Sequoyah Nuclear Plant, Units 1 and 2  
Facility Operating License Nos. DPR-77 and DPR-79  
NRC Docket Nos. 50-327 and 50-328

**Subject: Documents for the Environmental Review of the Sequoyah Nuclear Plant, Units 1 and 2, License Renewal Application – Env 2.B (TAC Nos. MF0057 and MF0058)**

#### **Revision to specific pages of the SQN Environmental Report**

**Figure 2.12-1**  
**SQN Site with Area of Potential Effect Shown**

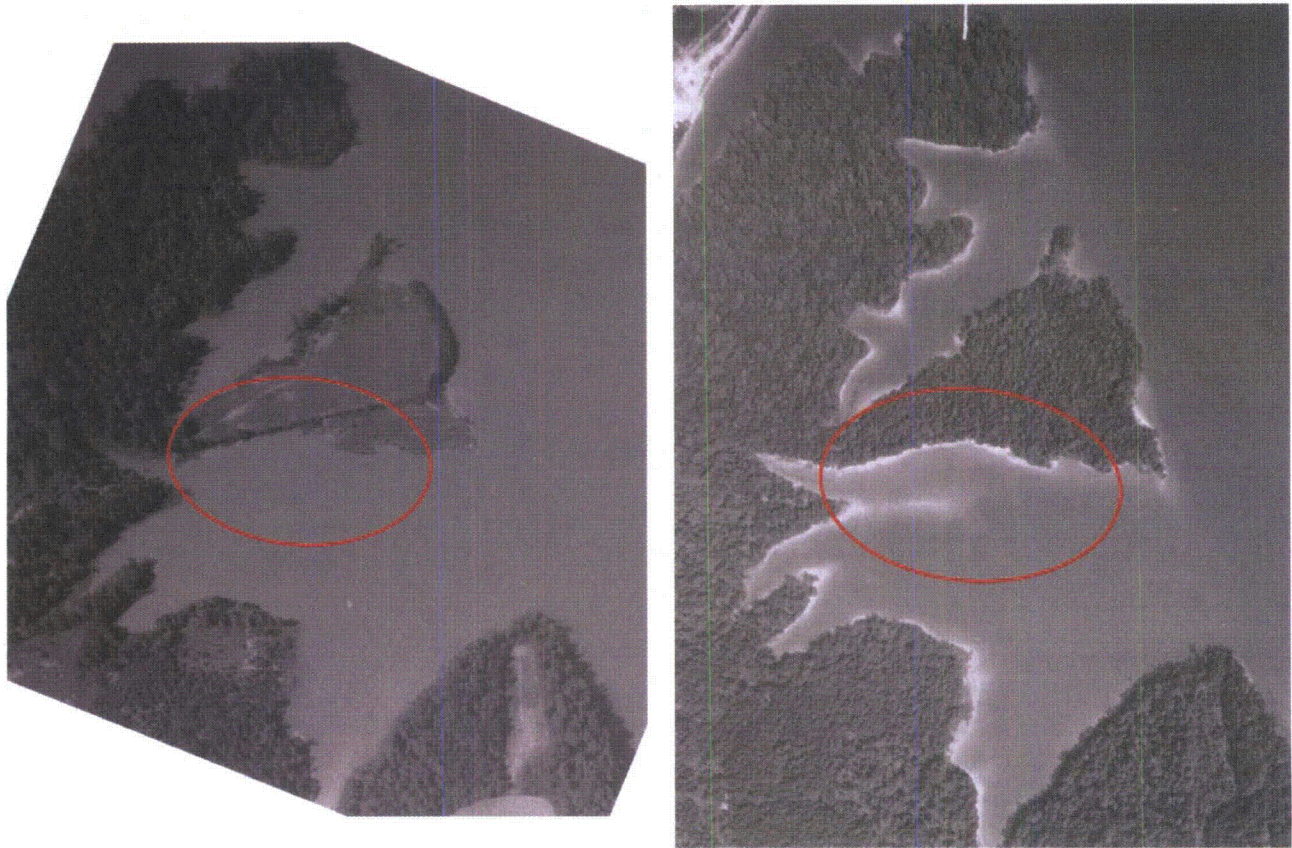
The second modern investigation was a Phase 1 archaeological survey conducted for the entire SQN site in early 2010 in preparation for the LRA (McKee et al. 2010). The APE for the survey was defined as the entire area occupied by SQN (Figure 2.12-1). The APE for architectural field studies included those portions of a 0.5-mile area surrounding the plant facility where a visual link to the plant was unobstructed by topography or vegetation (McKee et al. 2010, page 1). The archaeological investigation focused on shoreline areas and the limited amount of undeveloped land within the APE.

**Figure 2.12-2**  
**Aerial Photographs of SQN Plant Site Prior to Construction**

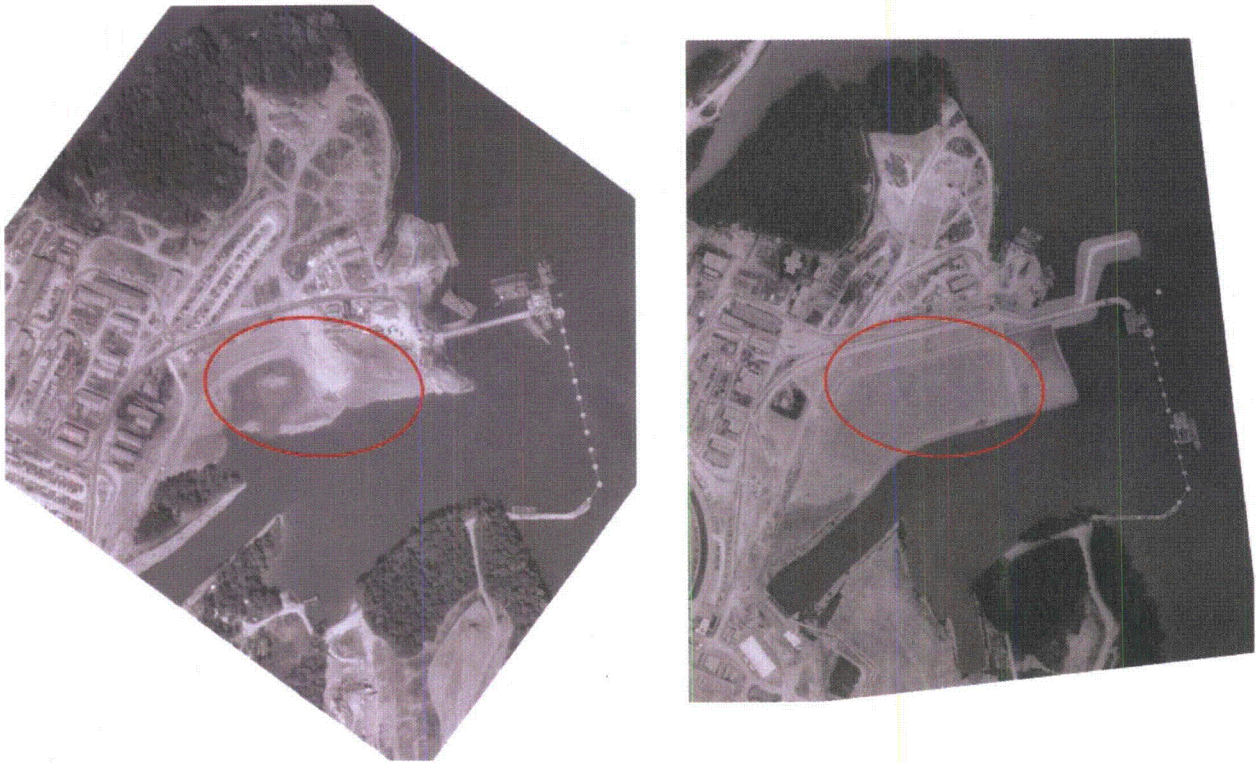
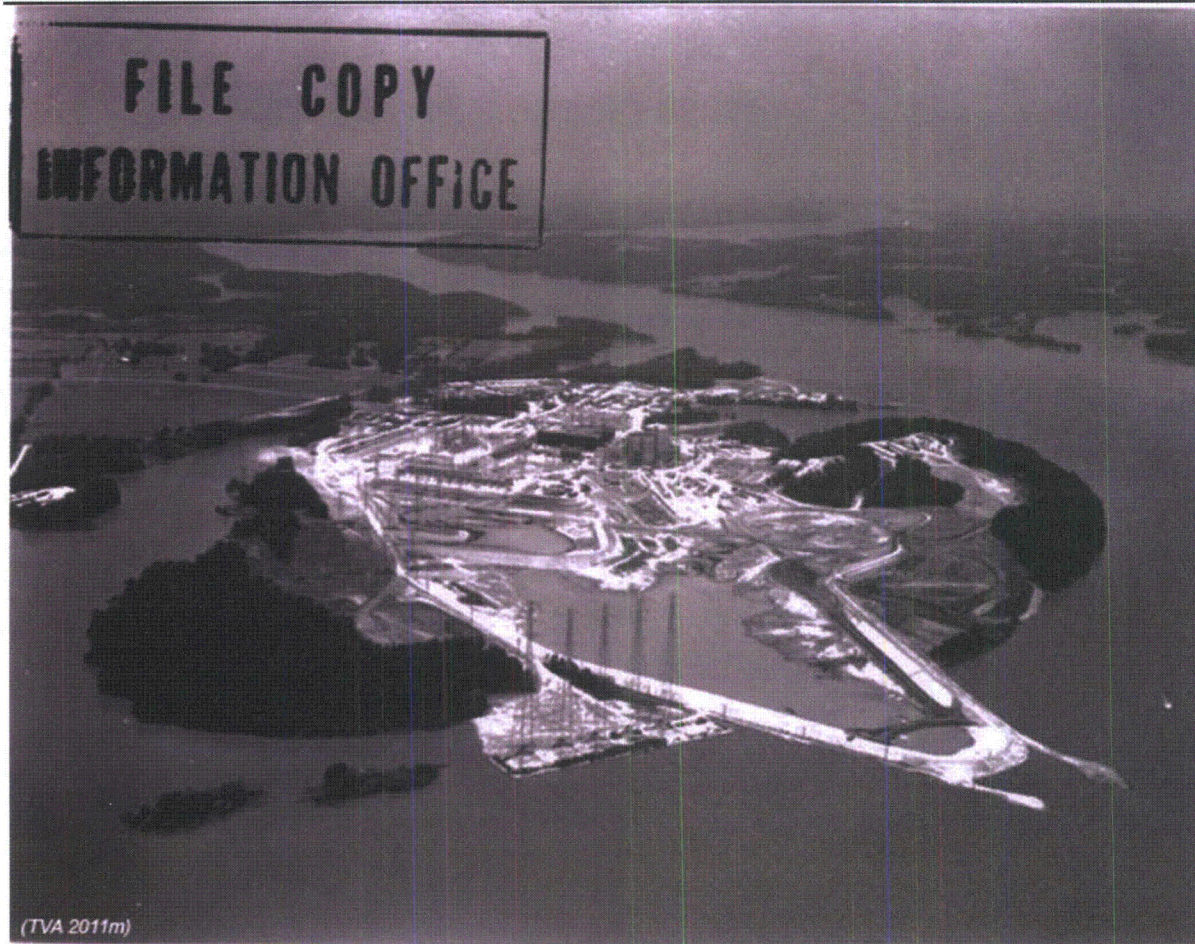
~~Results of t~~ The 2010 Phase 1 archaeological survey confirmed the 1973 findings that sites 40HA20 and 40HA22 were destroyed during plant construction. Figures 2.12-3 and 2.12-4 document construction-related disturbance in the locale of site 40HA20 identified no traces of sites 40HA20 or 40HA22. The report authors concluded by agreeing with Calabrese et al. (1973) that both sites were completely destroyed during construction of SQN. Figure 2.12-2 documents the SQN plant site prior to construction, showing the locale of site 40HA20 in May 1951 (left) and August 1968 (right). Figure 2.12-3 documents the SQN site during construction in October 1977 (left) and after construction in June 1980 (right). Figure 2.12-5 Figure 2.12-4

Figure 2.12-4  
Oblique Aerial Photograph Taken During SQN Plant Construction  
Between October 1971 and February 1973

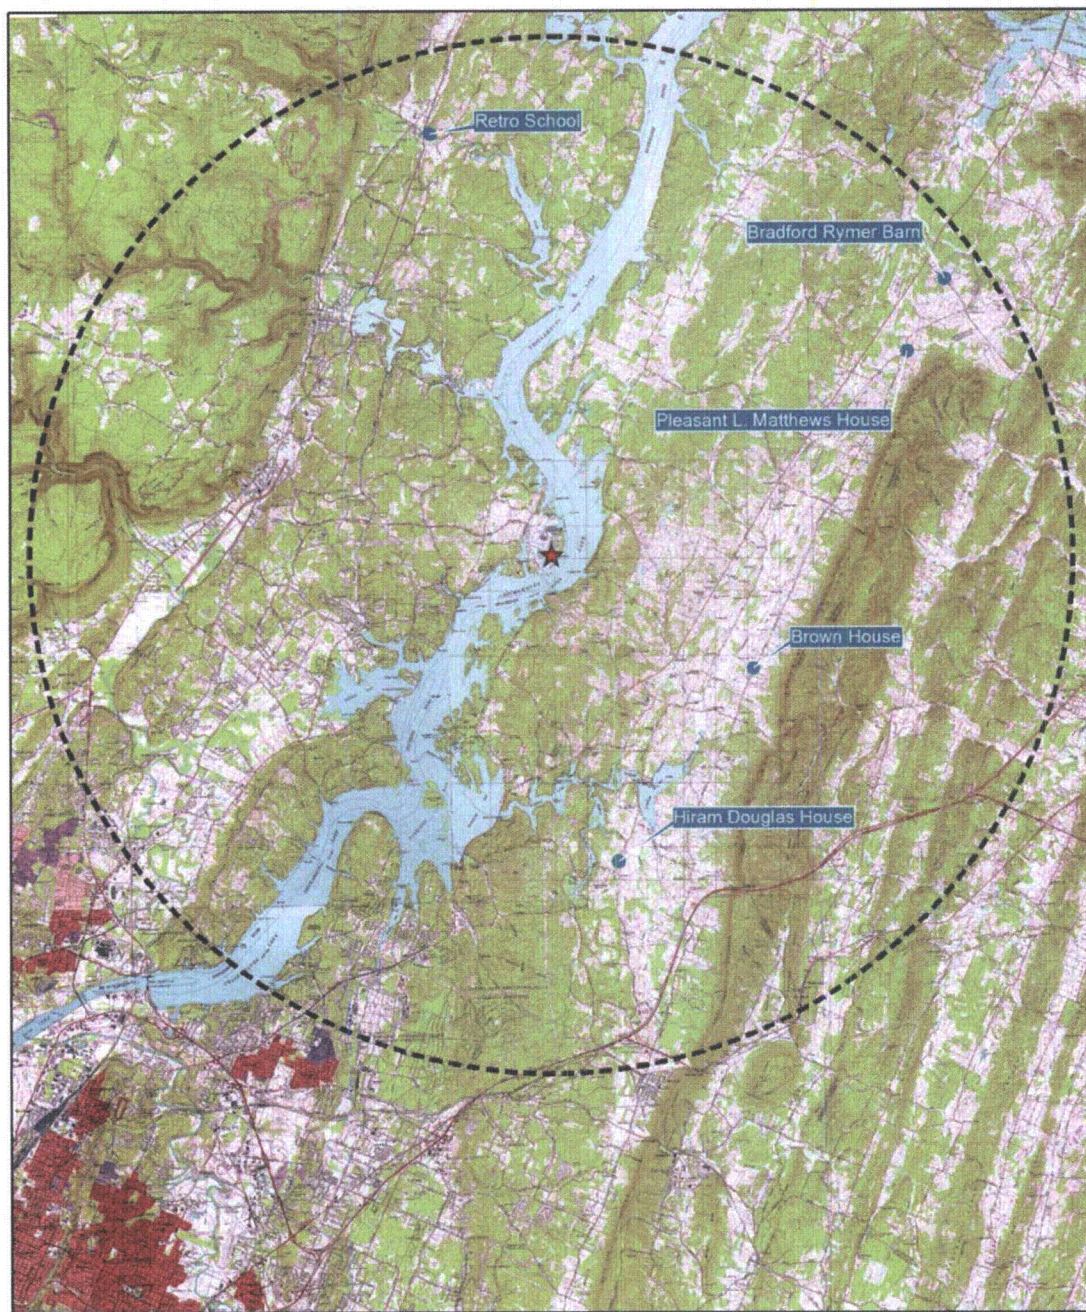
shoreline by a small distance, immediately west of a row of transmission structures (visible in Figure 2.12-4). In TVA's subsequent consultation with the Tennessee SHPO regarding the DEIS for the SQN Units 1 and 2 operating license renewal in October 2010, the correct APE was presented, which excluded those islands (see Attachment B).
